Car Stereo
Service Bulletin

Model: CDX-A10

No. 106

Subject: Replacement Of Flexible PCB

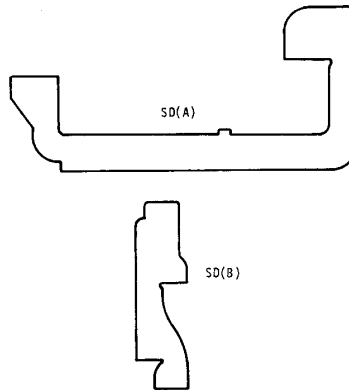
The flexible PCB (Part Number 1-617-350-11) is no longer available.

Solution: It has been replaced with two new flexible PCBs.

Description	Part Number
SD (A) Flexible PCB	1-620-082-11
SD (B) Flexible PCB	1-620-083-11
